Planning Board AGENDA

- 1) Amended Site Plan-223 Garden Street-Zebian
- 2) Site Plan-699 Silver Street-MSR Properties, LLC
- 3) Request for Bond Release-61 Hemlock Ridge
- 4) Approval of Minutes-April 2, 2026
- 5) Correspondences

Proposed Building Addition

223 Garden Street
Agawam, MA
Parcel ID: G8-2-3

BITUMINOUS CONCRETE PAVING DETAIL
NO SCALE

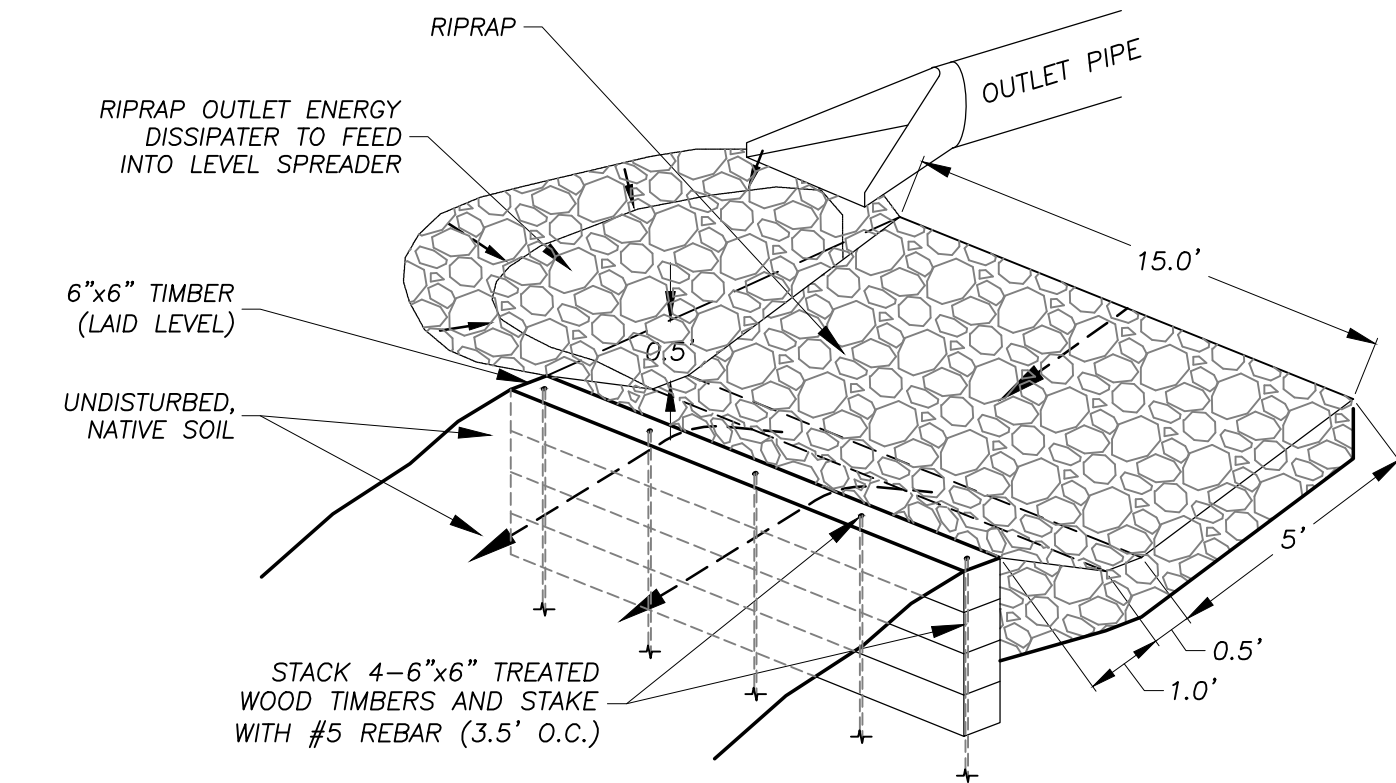
2) The pavement detail on sheet D-1 shows a 2" binder course. Engineering recommends a 3" binder course.

RLA Response: The detail has been revised. See sheet D-1.
